DEVELOPMENT APPLICATION ASSESSMENT REPORT

Application Number:	DA2019/0335
----------------------------	-------------

Responsible Officer:	Jordan Davies
Land to be developed (Address):	Lot 31 DP 33000, 84 Hilma Street COLLAROY PLATEAU NSW 2097
Proposed Development:	Alterations and additions to a dwelling house
Zoning:	Warringah LEP2011 - Land zoned R2 Low Density Residential
Development Permissible:	Yes
Existing Use Rights:	No
Consent Authority:	Northern Beaches Council
Land and Environment Court Action:	No
Owner:	Diana Juliette Arena Richard Eugene Arena Lauren Alyce Arena Jesse Louise Arena Thomas William Diego Arena
Applicant:	H & C Design Pty Ltd

Figure 3 - Extract of south and north elevation showing areas of non-compliance with wall height and envelope.

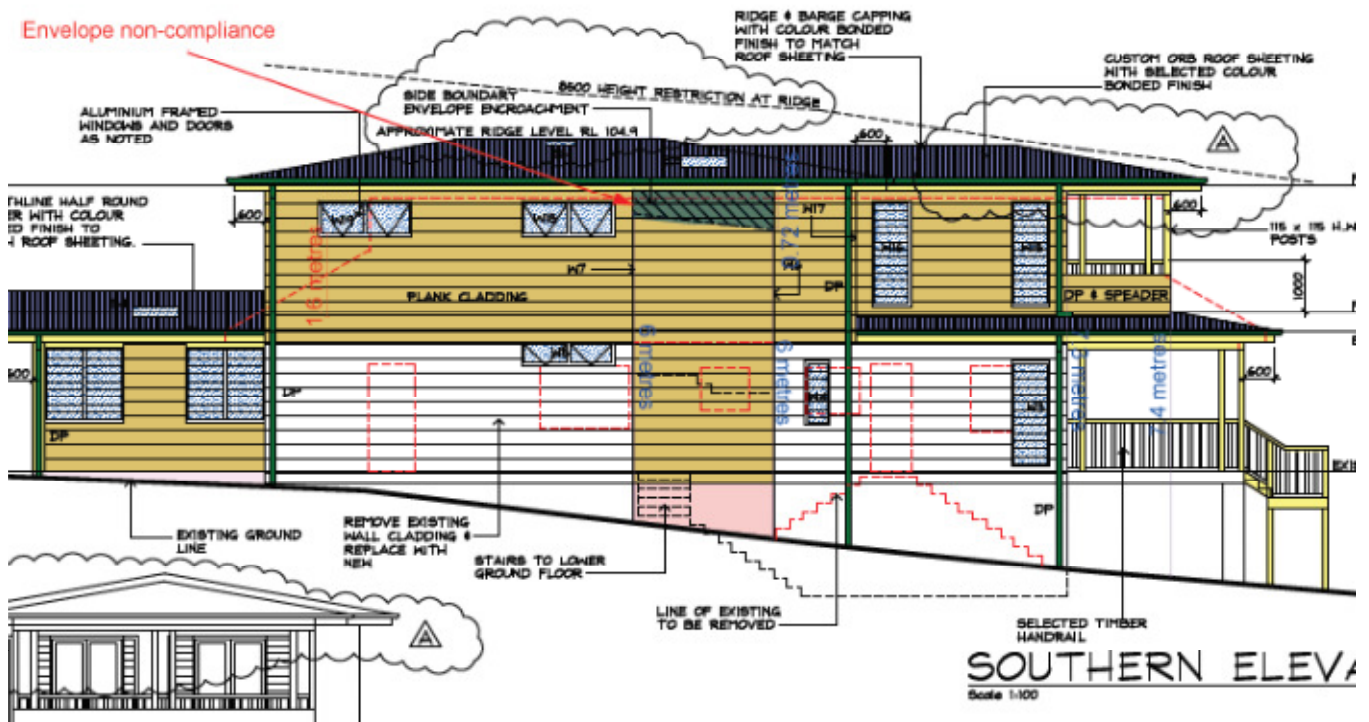
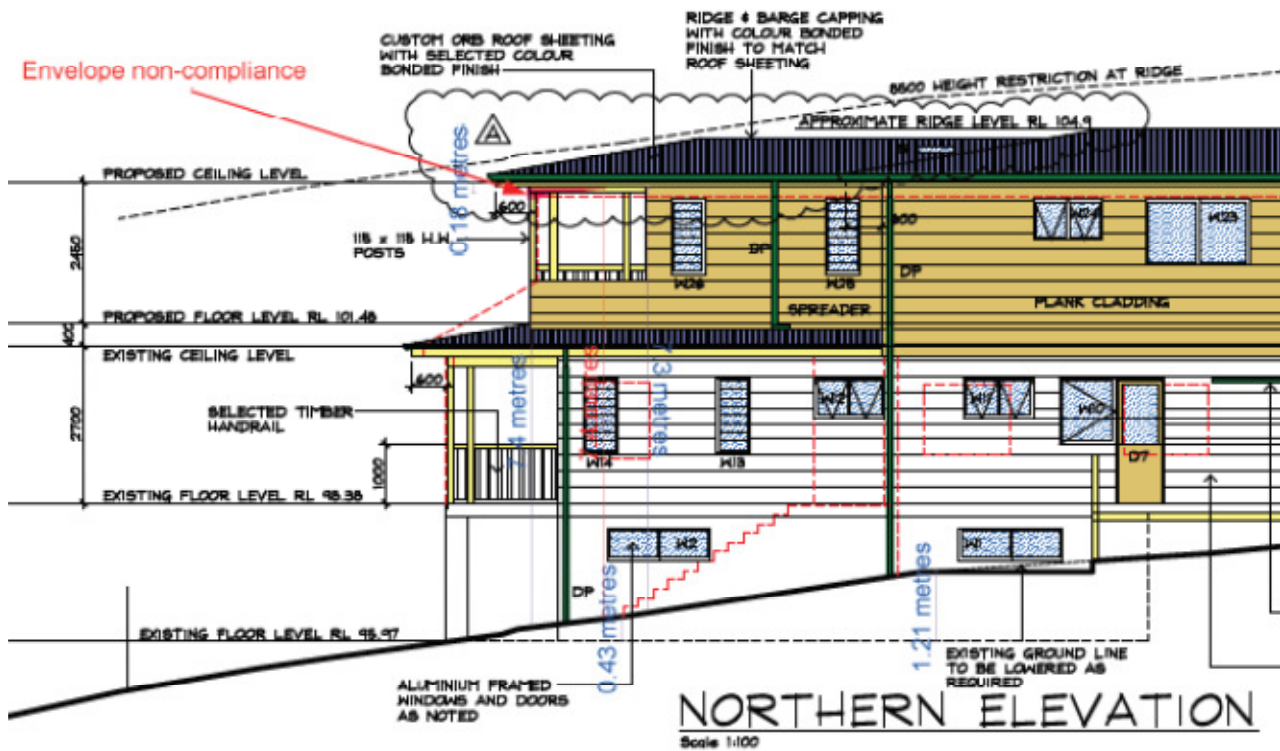
The DCP requires wall heights to be a maximum of 7.2m. The proposed dwelling has a maximum wall height of 7.3m on the northern and southern side at the front of the dwelling. This represents a variation

The DCP requires compliance with a 5m building envelope projected from the side boundary at a 45 degree angle. The proposed dwelling has two (2) areas in which the building envelope is encroached. Firstly, the front balcony on the northern side encroaching the envelope up to 180mm. Secondly, the wall on the southern side encroaching the envelope up 720mm consisting of a proposed stairwell between the ground and upper floor.

The non-compliance on the southern side is central to the dwelling wall and 2.5m in length. The remainder of the dwelling on the southern side is stepped back from the boundary and compliant with the envelope. This minor stepping of the facade to accommodate the stairwell not considered to render the building excessive in terms of its bulk and scale.

The development will not present an adverse visual impact when viewed from the street and adjoining properties as the built form is consistent with the character of Hilma Street consisting of two/three storey dwellings. The non-compliance with wall height is present over the lowest point of the site, with a compliant built form proposed as the land slopes upwards towards the rear. Further, the visual impact is minimised by stepping the proposed upper floor in from the boundary to articulate the higher section of wall at the front of the dwelling.

A detailed assessment of views is undertaken later within this report (see discussion under control D7 Views). The minor non-compliance with the wall height (100mm) will attribute to a limited additional impact with regards to views, as any impact upon views is as a result of the ridge of the roof. Internal floor to ceiling heights have been minimised (2450mm) to assist in limiting the overall wall height and roof height to limit any impact to views.

The proposed upper floor addition is visibly stepped in from both side boundaries over the lowest point of the site to assist in reducing the apparent bulk of the building as viewed from the street and adjoining property. The area of non-compliance on the northern side consists of a balcony, which does not attribute to the excessive building bulk by virtue of the 'open' sides.
